LINCOLN CITY/LANCASTER COUNTY PLANNING STAFF REPORT

for August 20, 2003 PLANNING COMMISSION MEETING

P.A.S.: Special Permit #2020, Randolph Square Community Unit Plan

PROPOSAL: CUP with 36 residential units, comprised of one 16-unit and two 8-unit apartment buildings, and 4 existing single-family homes.

LANDSCAPE PLAN
SCALE 1" = 40'

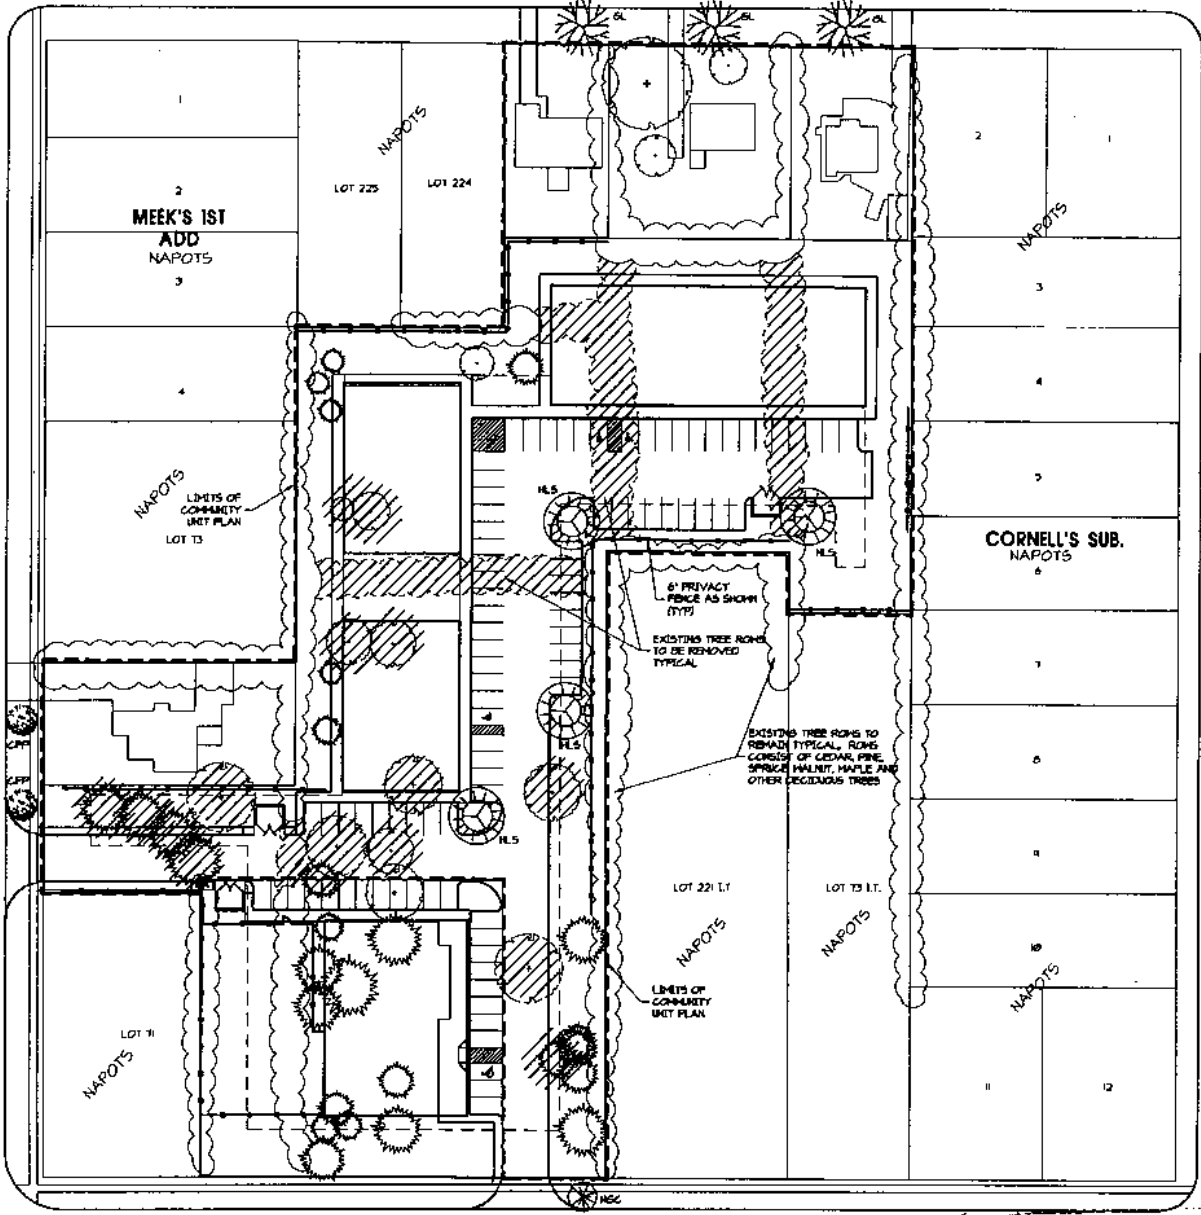
21. The waiver of additional landscaping is not appropriate in this case. There appear to be existing mature trees located along much of the property line. Applicant appears to have requested this waiver on the basis that the existing trees provide adequate screening. Therefore, Applicant should revise the landscape plan to include those trees that are located on their property in screening calculations. Once it has been determined that the existing trees are insufficient to meet minimum screening requirements, Applicant may request a waiver.

- 1.2 Revise the landscaping plan to show:
 - 1.2.1 Indicate those trees that are located on Applicant’s property and demonstrate whether they meet the minimum Design Standards.

- 1.2.2 Add to note 2 a provision that any tree removals will be replanted if there are trees designated to remain but removed due to construction and/or damage.

1.2.4 All proposed tree removals, including those on City right-of-way must be shown on the revised plan.

1. Revised plans need to be resubmitted.
2. All proposed tree removals, including those on City right-of-way must be shown on the revised plan.
3. Landscape Notes (No. 2) states that owner/developer reserves the right to remove dead and/or damaged trees in addition to removals indicated. Such removals should be replanted if there are trees designated to remain but one removed due to construction and/or damage.
4. Private roads need to have street trees spaced according to the City of Lincoln Standards on Street trees.
5. A Community Recreation Plan needs to be included showing a ½ court basketball court, swing, spring toys; recreation opportunity for all ages.
